Response to Submissions Staged DA (SSD 5248)

813-819 Wallgrove Road, Horsley Park

Gazcorp Industrial Estate, Western Sydney Employment Area

Submitted to Department of Planning and Environment
On Behalf of Gazcorp

Figure 2 – Aerial image dated November 2014 of the subject site and surrounding development

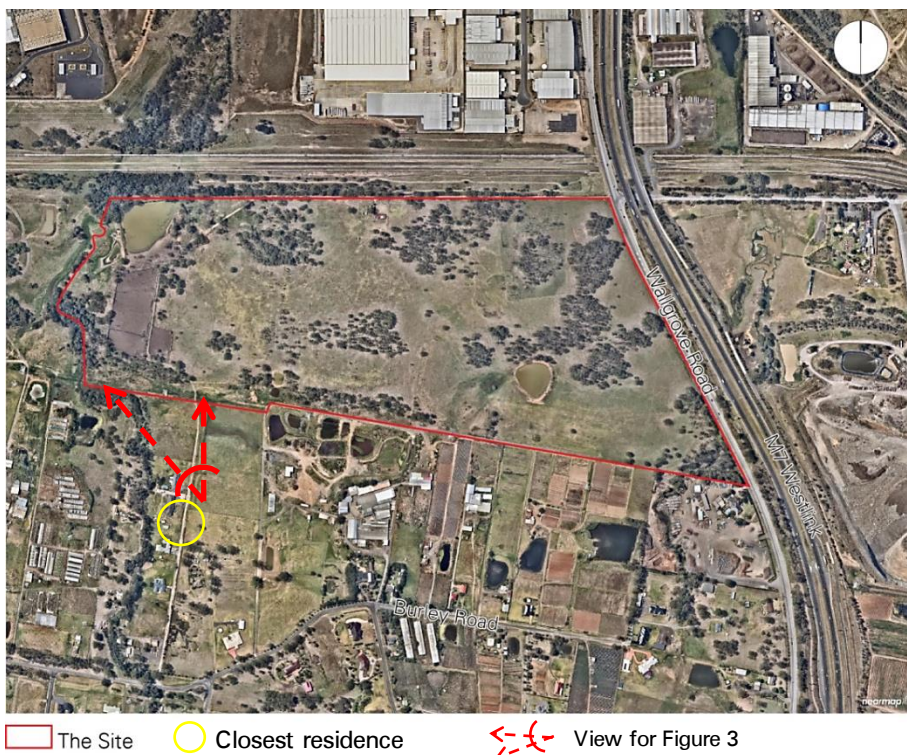
The closest residence to the south of the site is located on Flavex Lane approximately 150m from the southern boundary. There is a row of residential properties stretching southwards along Flavex Lane, south of the closest residence. The closest residential receptor is shown in **Figure 2**, in the context of the site boundary.

Further consideration of the views from these residential properties on Flavex Lane has been requested by DP&E and FCC, as well as in public submissions. In particular submissions requested further consideration of the installation of a landscaped mound combined with a masonry wall to provide improved amenity outcomes for residents.

A more detailed landscape plan has been prepared (see **Appendix H**), which includes a perspective of the Stage 1 warehouse building viewed from the south. The perspective is provided in **Figure 3**, and **Figure 2** illustrates the approximate vantage and outlook for the perspective.

It should be noted that the orientation of three closest residences is towards the west, taking in views of the creek and associated riparian corridor vegetation, as can be seen in **Figure 4**. There are no significant existing vistas towards the site from the nearest residences, and the view towards the site from the south is also impacted by an existing 330kV electricity transmission line (including a pylon).
